**JOINT DEVELOPMENT CONTROL FORUM
DARWIN GREEN ONE - BDW2 (19/1056/REM)
BDW CAMBRIDGESHIRE
22 JANUARY 2020**

INTRODUCTION

Proposed layout as submitted under application 19/1056/REM.
Massing proposal submitted under application 19/1250/S73 for Grosvenor Court incorporated.

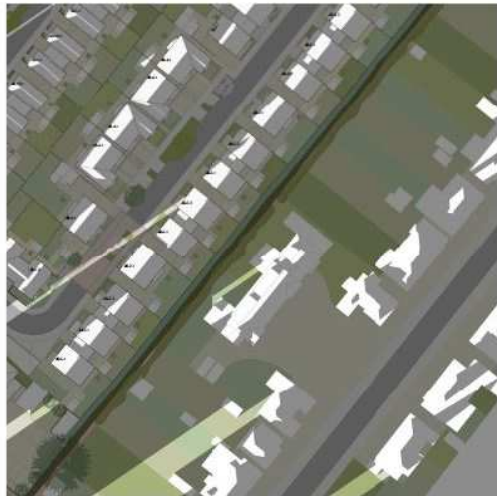
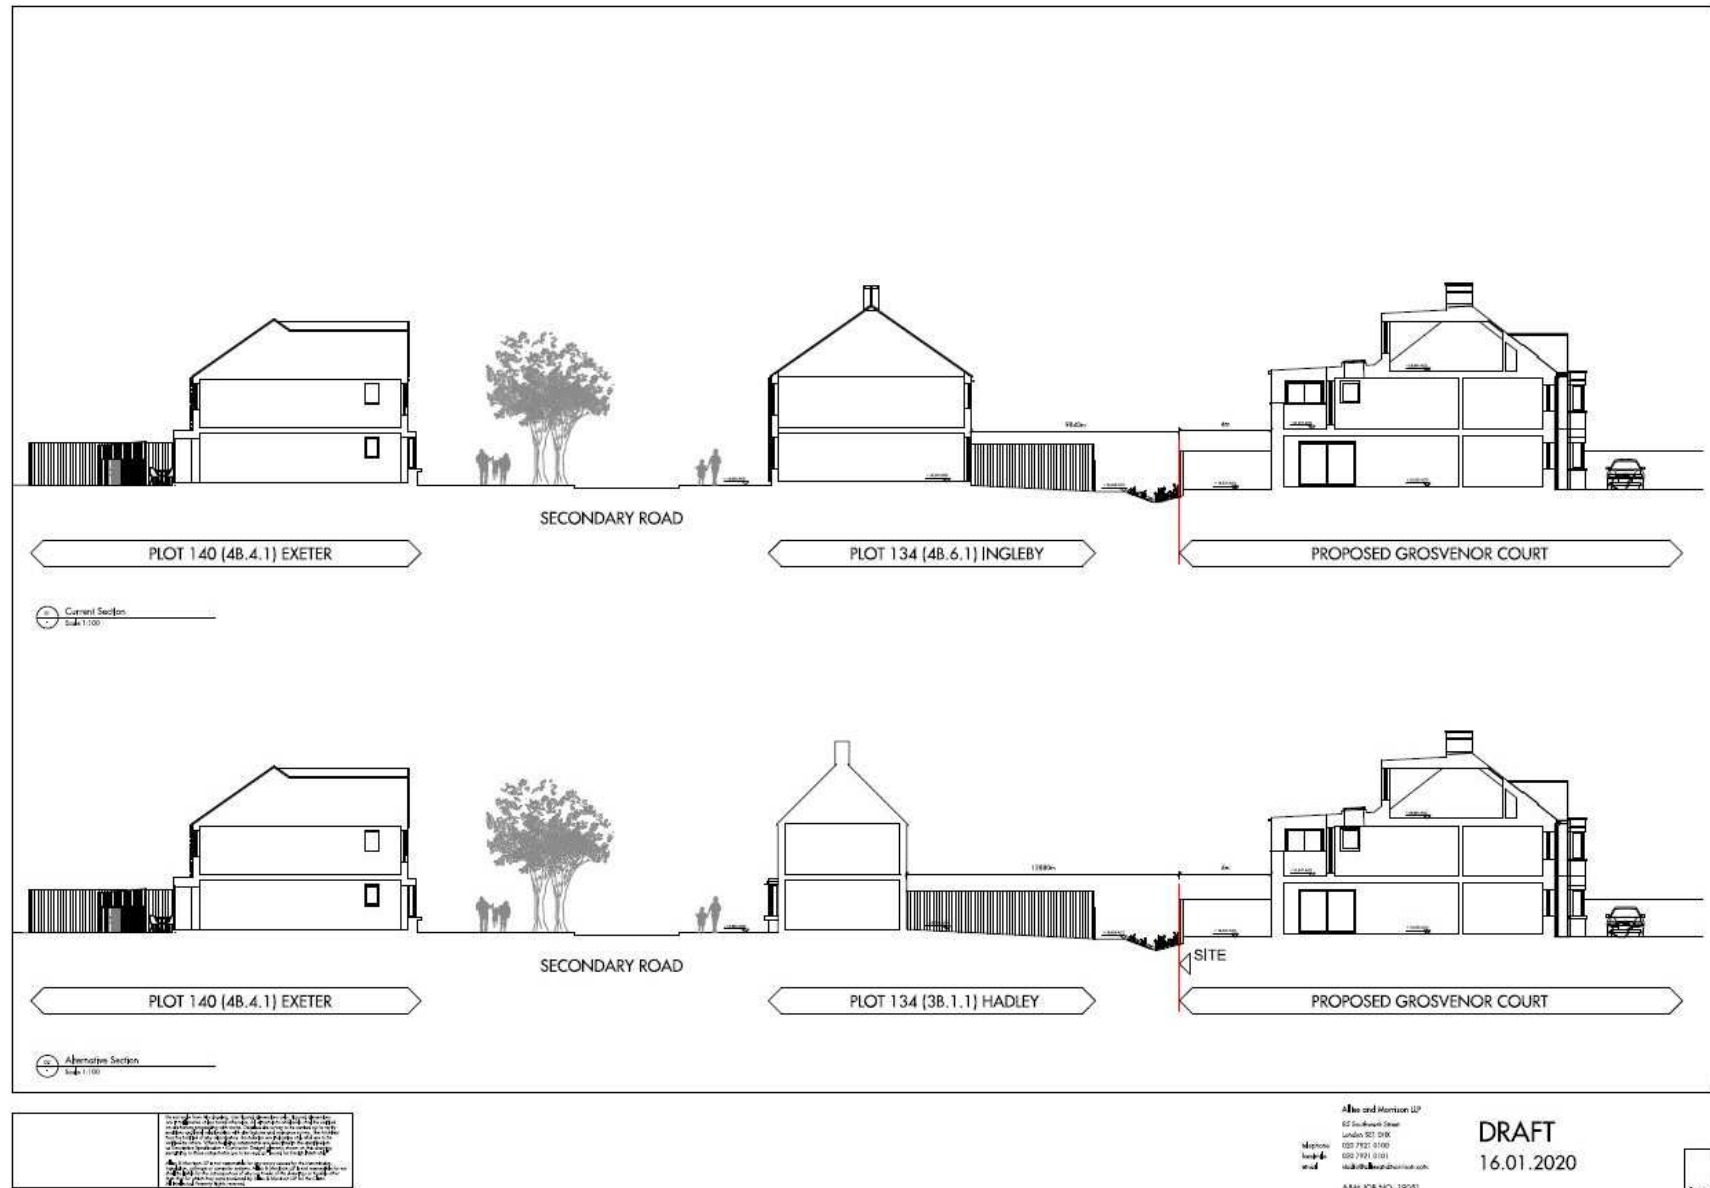
The plans submitted illustrate a historic view of the houses and flats on Woodlark Road and do not reflect the recent planning permission for the rear extensions at Grosvenor Court, or alterations and extensions to the houses in Woodlark Road over the last 10 years. The plans are therefore inaccurate. Consequently, it is not possible to ascertain accurately the impact of the new development, particularly on overlooking and daylight/sunlight issues on the existing community.

The plans for the BDW2 development should be updated with the correct drawings for the houses along Woodlark Road and the planning application resubmitted. The current drawings are misleading and incorrect.

The proximity of the new development to existing perimeter buildings on Woodlark Road is too close. This is particularly relevant for 131-136 in the BDW2 plans.

The gardens behind the BDW2 houses that run parallel to Woodlark Road should be 20 metres in depth as indicated on the original pre planning drawings shown at public meetings, with an orientation that inhibits any overlooking and a size that does not impact daylight/sunlight issues.

Study undertaken on proposed layout submitted under application 19/1056/REM.
Massing proposal submitted under application 19/1250/573 for Grosvenor Court incorporated.

Study undertaken on proposed layout submitted under application 19/1056/REM.
Massing proposal submitted under application 19/1250/573 for Grosvenor Court incorporated.

Drawing
**Drainage Strategy
- BDW Parcels**

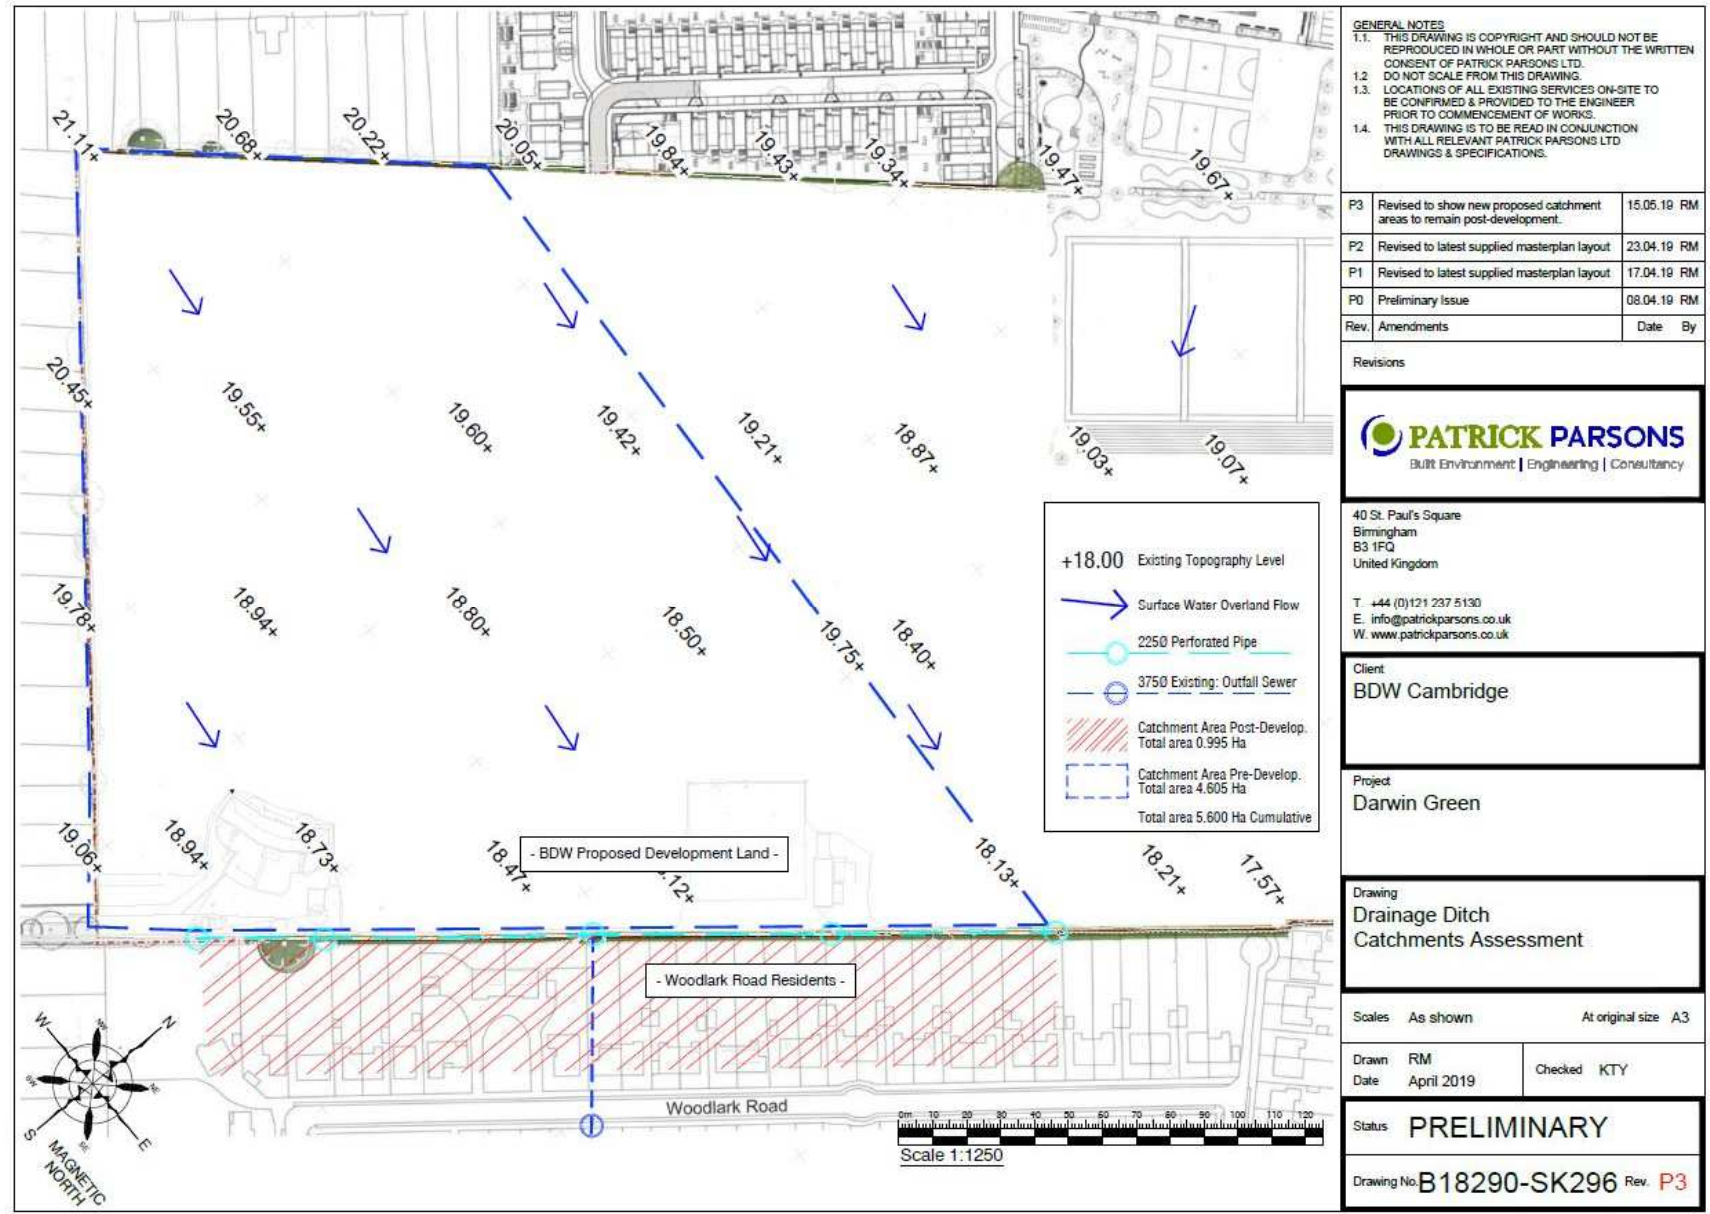
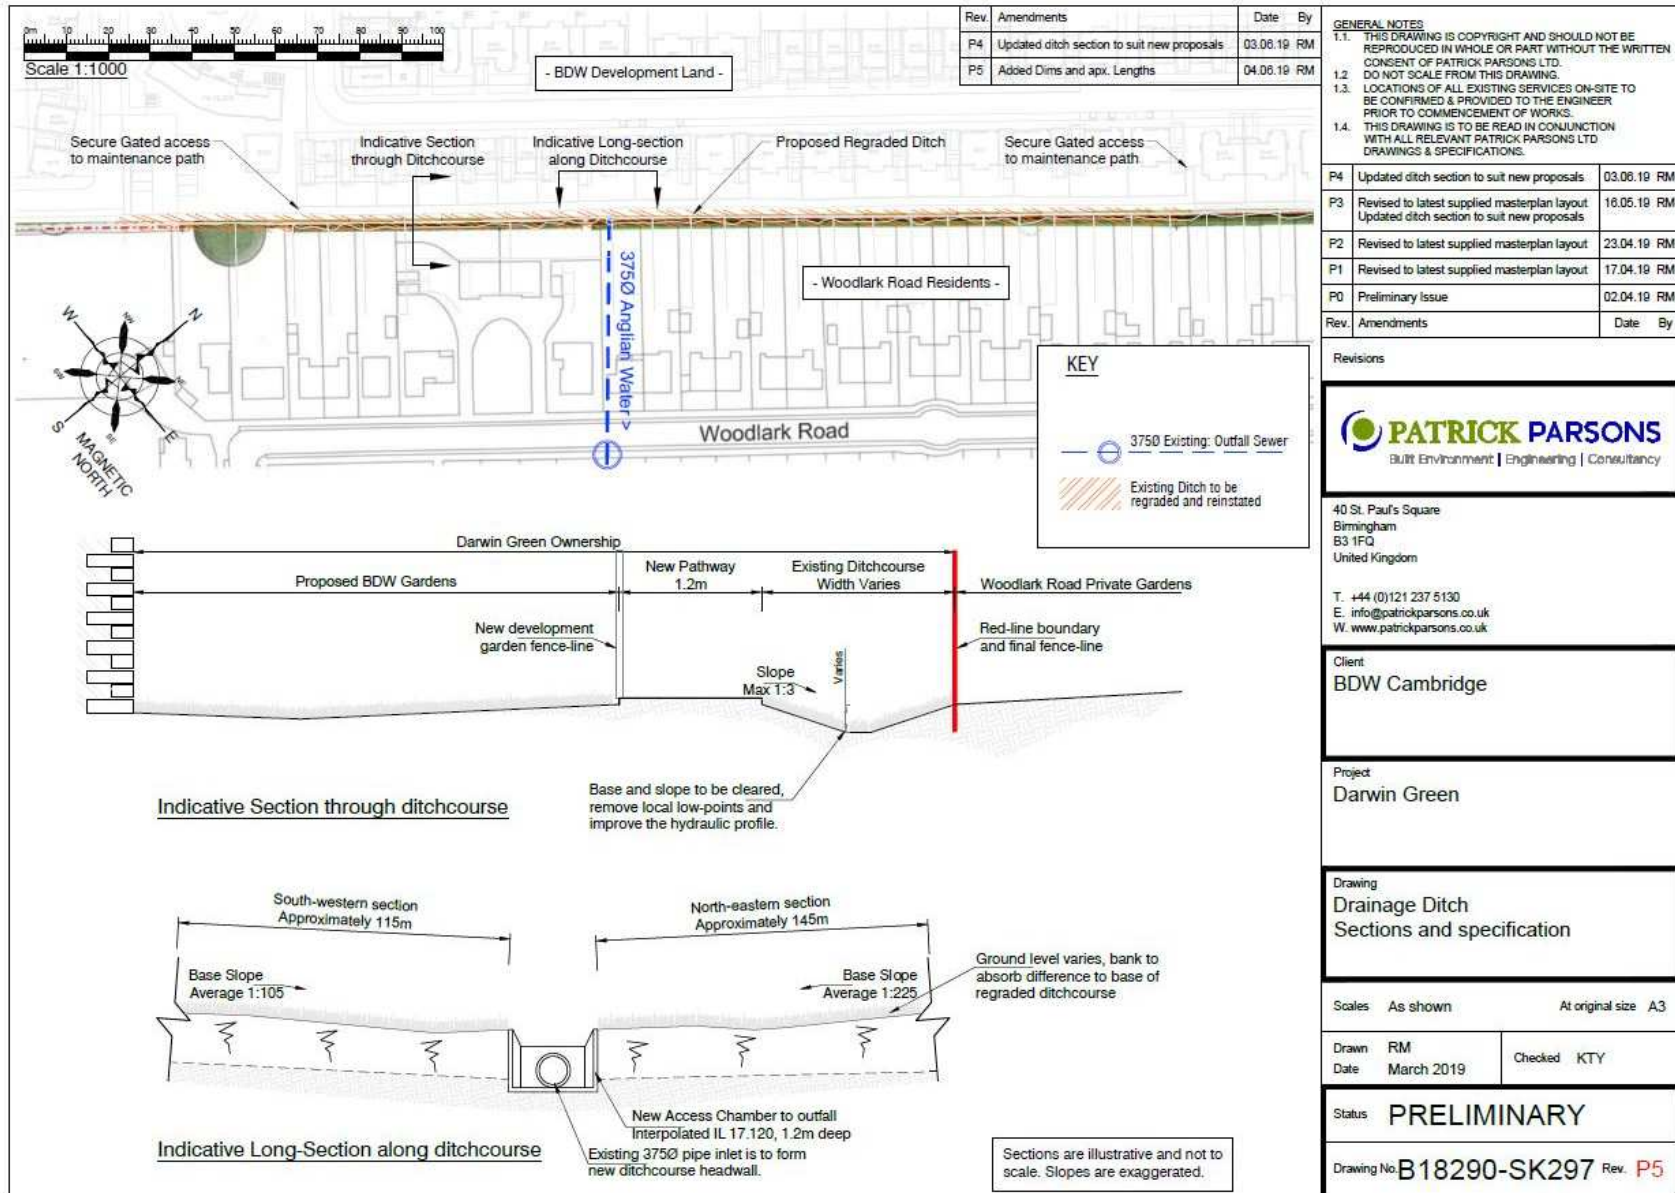
There is a real risk of flooding in the ditch which runs parallel between Darwin Green and Woodlark Road:

- a) More information needs to be provided about how the long term maintenance of the ditch will be funded. The information provided does not meet the requirements of condition 35 of the outline conditions.
- b) The security implications of the maintenance path, which runs parallel and behind the Woodlark Road, needs more consideration in its design.
- c) There is also concern that the drainage on the Darwin Green site does not have adequate capacity to allow for climate change. The proposed drainage system could be overwhelmed by heavy sustained rainfall and subsequently the overflow could cause flooding to the surrounding areas.

The drainage scheme should be reviewed to ensure it meets the required 100 year flood risks taking into account the impact of climate change. This should be carried out by an independent body. Information should also be provided on the company who will be responsible for the maintenance of the ditch along the Woodlark Road gardens.

- **Part 5a** – the ditch is not part of the strategic drainage scheme approved pursuant to condition 34 and for which the RM details would need to adhere to. The site does not discharge into the ditch. This has been investigated and the Local Authority is satisfied this is the case.
- **Part 5b-** The rear garden fences will be lowered to afford surveillance to the ditch from the rear gardens. The gates will be perpetually locked. The Local Authority is satisfied with the arrangement.

Part 5c-

This development will be in full accordance with Cambridge's Full Local Plan 2018 guidance.

The drainage strategy is to follow Policy 31:

- We confirm Surface water is being managed close to the source.
- Individual Plot drainage, minimum 2.5m³, is being provided where feasible.
- Surface SUDs features will be used such as Swales, bio-diversity areas and Rills.
- Run off from hard surfaces will receive an adequate level of treatment.
- All vehicle trafficked areas are to be permeable surfaces with underdrains.

We are also following Policy 32:

- The peak runoff from the whole Darwin development is subject to the previously approved site-wide Masterplan. We can confirm that BDW2 will have discharges reduced to suit this plan and the designed wide network.
- We can confirm that the storage design is for the 1:100 year storm event range and will include a +25% allowance for climate change and will not flood properties.
- The discharge locations for foul and surface water will have capacity.
- We can confirm that an operations and maintenance plan will be provided for the features introduced and provided to the developer.
